## **ADDENDUM NO. 1**

### **NJ STATE POLICE BARRACKS BUILDING**

February 2, 2024

P1.0 – Below First Floor Plumbing Plan

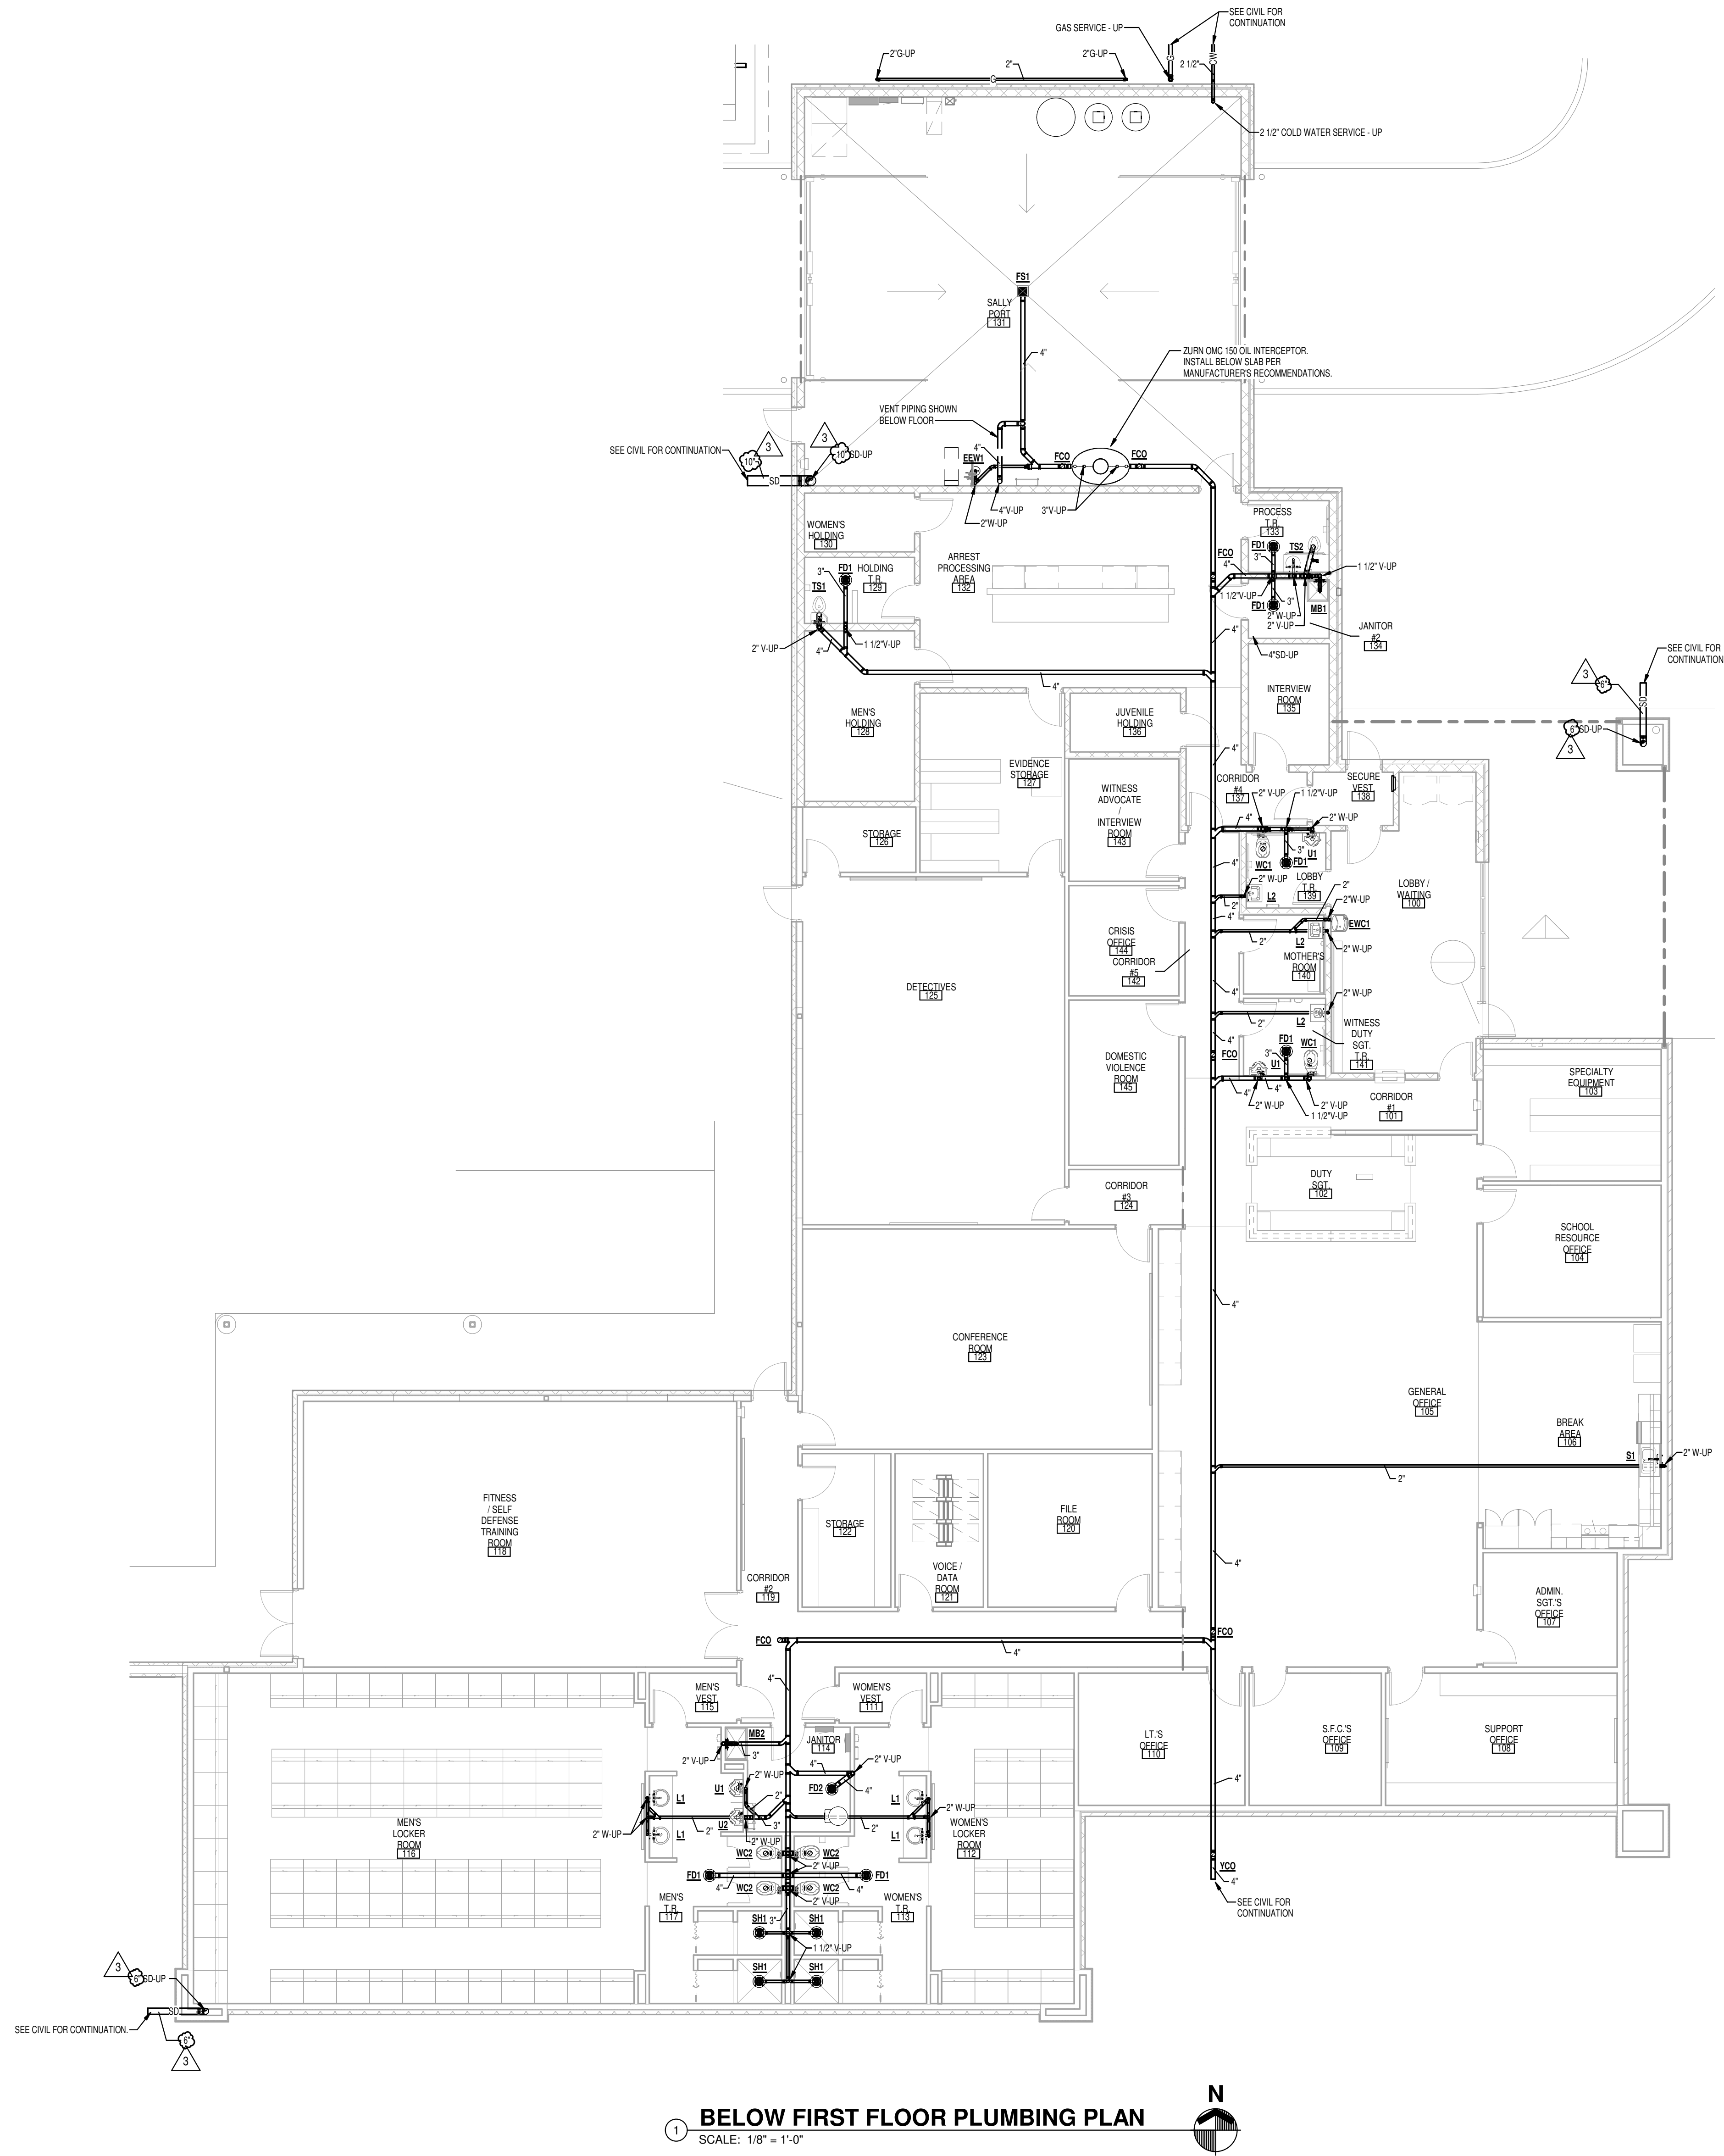
Roof drain piping sizes were increased throughout the building to accurately reflect the roof areas connected to each drain. These changes are bubbled and marked by a Revision 3 tag."
